AGENDA ITEM 11

TO: Mountain Village Design Review Board

RE: Staff Memo – Initial Architecture and Site Review (IASR) for Lot 644, 327 Adams Ranch Rd.

APPLICATION OVERVIEW: New Multi-Family Development Deed Restricted Condominiums on Lot 644

Sheet A1.0

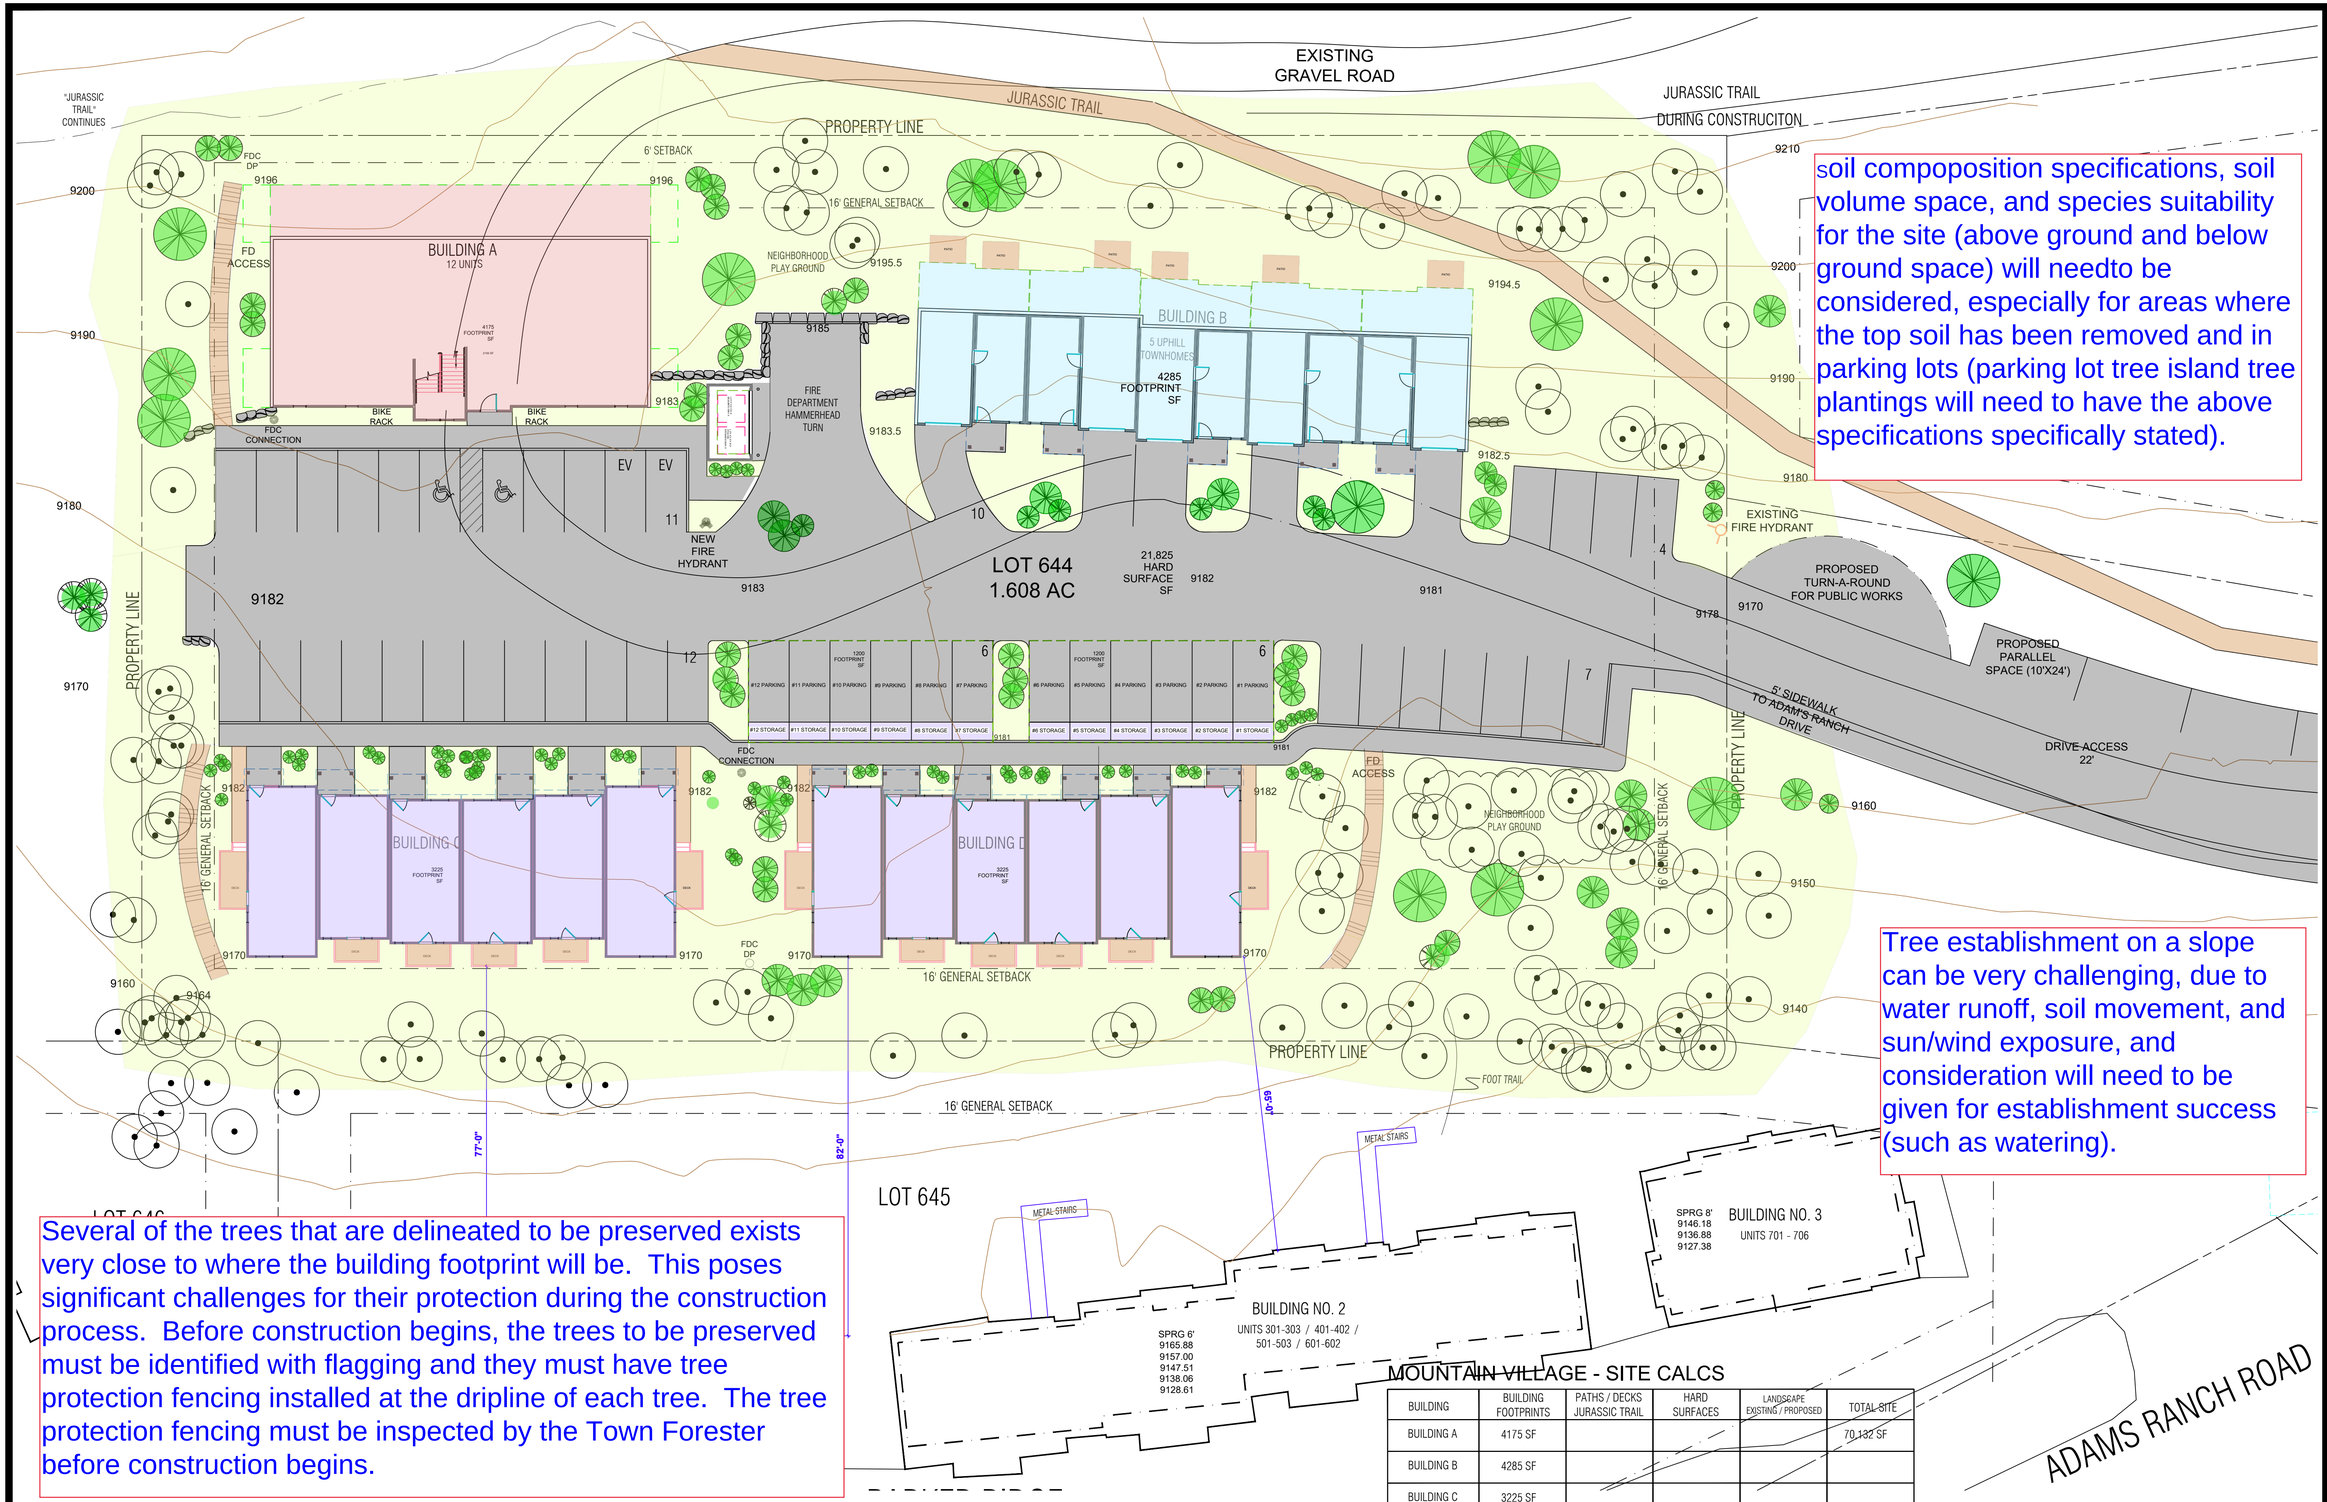
soil compoposition specifications, soil volume space, and species suitability for the site (above ground and below ground space) will needto be considered, especially for areas where the top soil has been removed and in parking lots (parking lot tree island tree plantings will need to have the above specifications specifically stated).

Tree establishment on a slope can be very challenging, due to water runoff, soil movement, and sun/wind exposure, and consideration will need to be given for establishment success (such as watering).

A landscape plan is required. This plan must contain a scale bar, north arrow, species description of each tree to be planted, location of tree protection fencing that must be installed prior to construction, limits of disturbance, and Zone 1 fire mitigation zone.

Sheet A1.5

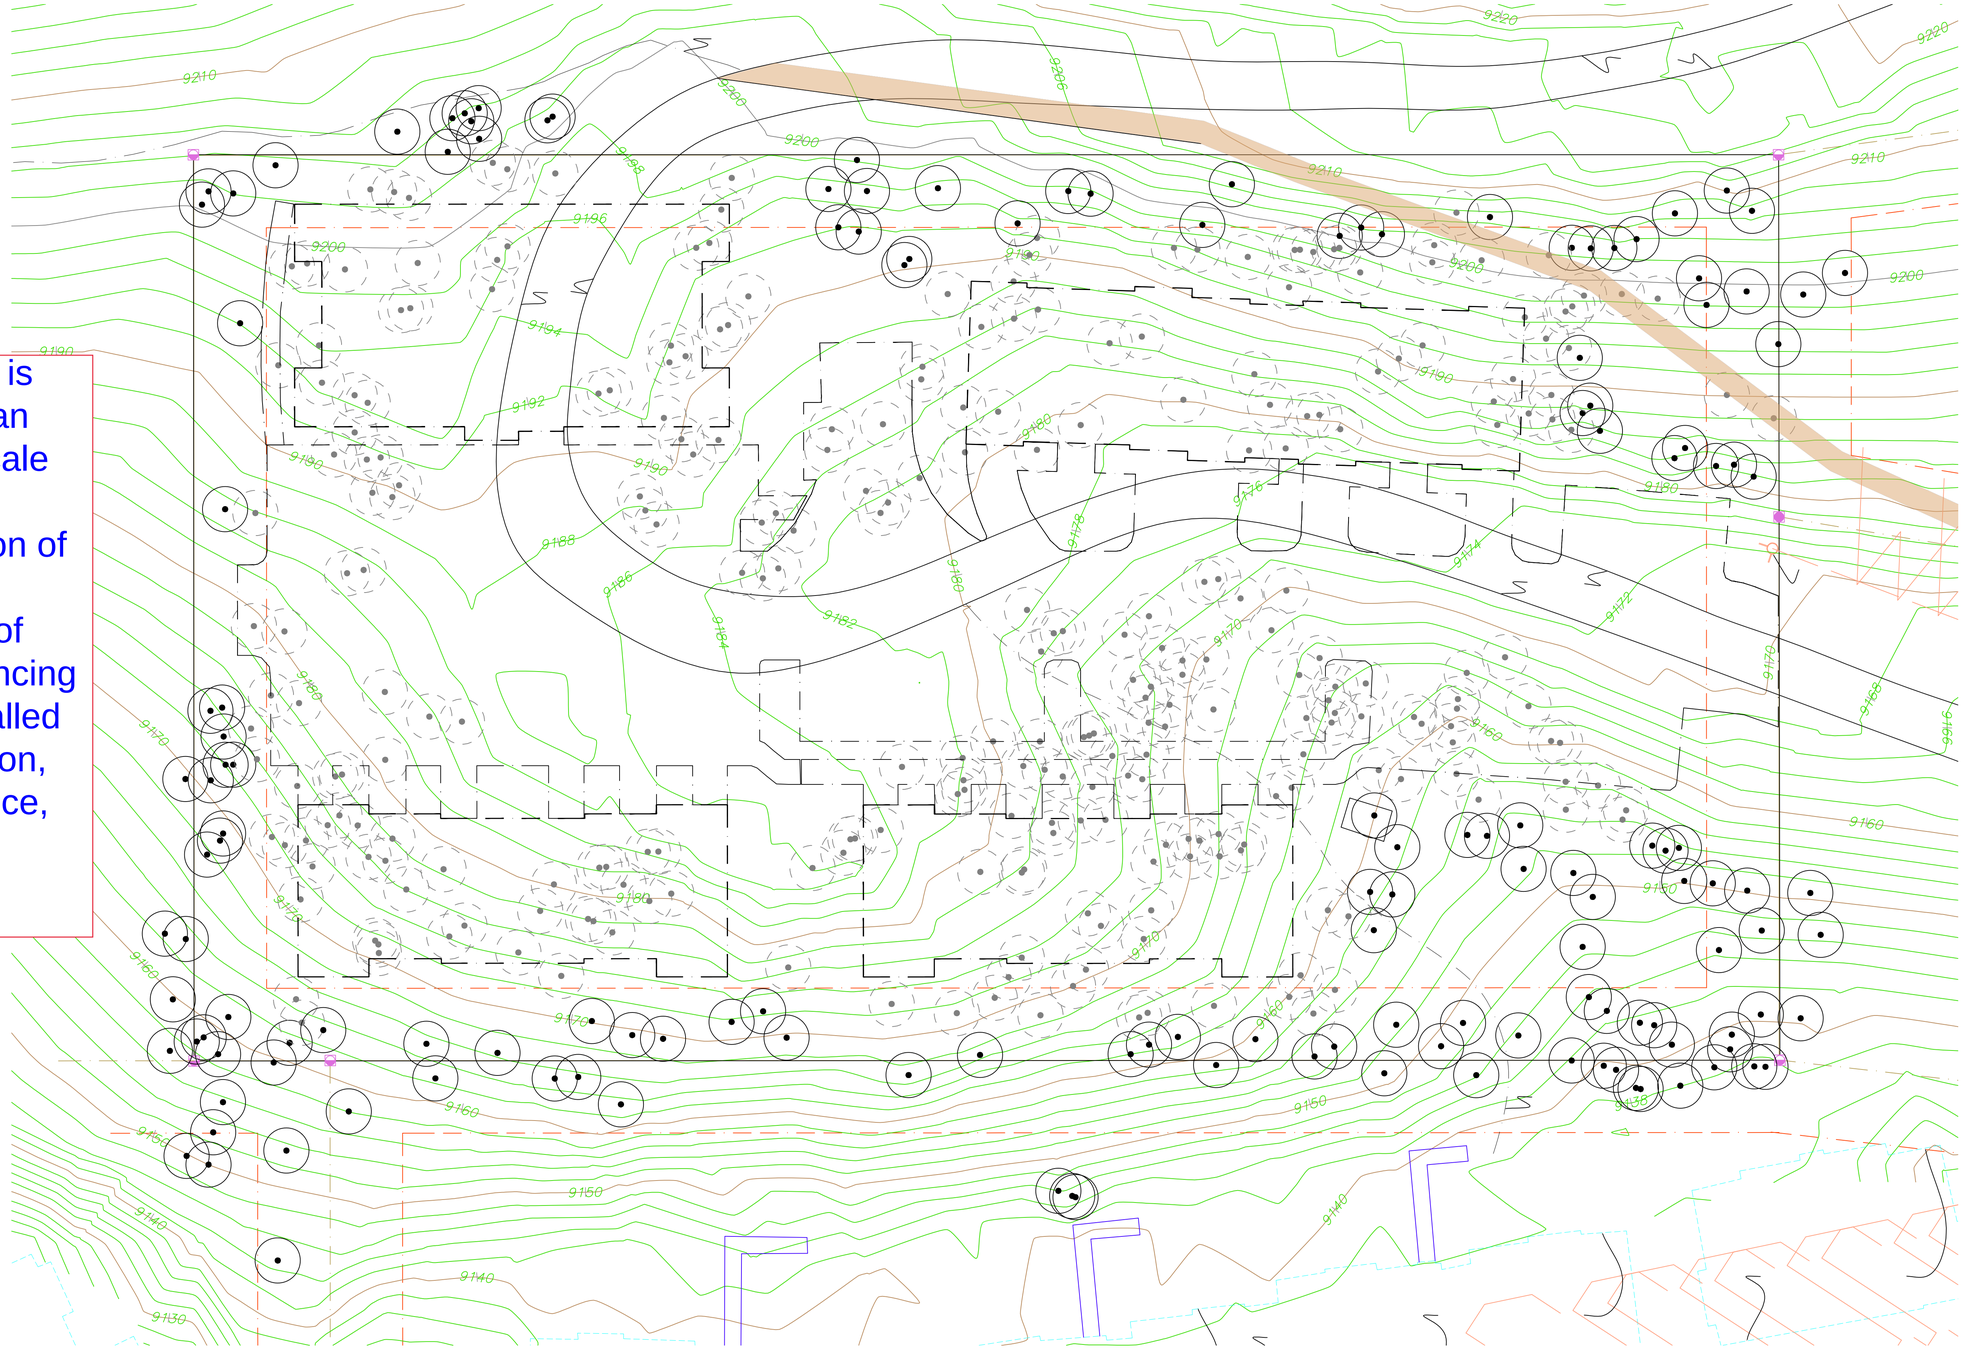
Staff: Fire Mitigation and Forestry Management: The applicant has included a tree removal plan but has not shown the fire mitigation zones indicated in the CDC. This should be revised prior to final review so we can understand whether all fire mitigation requirements are being met.

3. Prior to final review the applicant shall revise the address monument design to meet all CDC regulations.
4. Prior to final review the applicant shall revise the fire mitigation/tree removal plan to include Zone 1, 2 and 3 fire mitigation area boundaries.
